SIB 51 15 22 GROANING SOUND IN THE D-PILLAR AREA

2022-10-25

E-Series	Model Description	Production Date
G26	4 Series Gran Coupe	July 1, 2021 – August 31, 2022

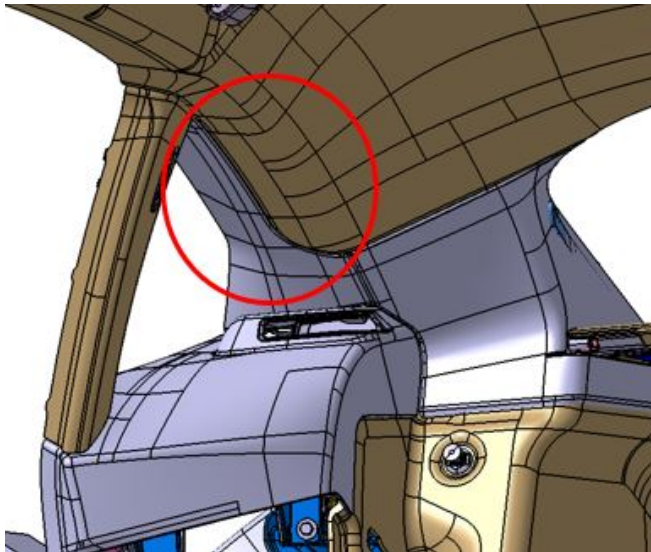
While driving on a rough road, a groaning sound is heard coming from the D-pillar trim panel and the headliner.

Unfavorable friction between the D-pillar trim panel and the headliner.

Apply film tape to the D-pillar as shown in the photo below. The film tape surface acts as a friction reducer.

2. Apply film tape to the D-pillar as shown in the photo.

- Vehicle at room temperature for best tape adhesion
- **Long side of the D-pillar: 215 mm length of tape**
- **Short side of the D-pillar: 65 mm length of tape**
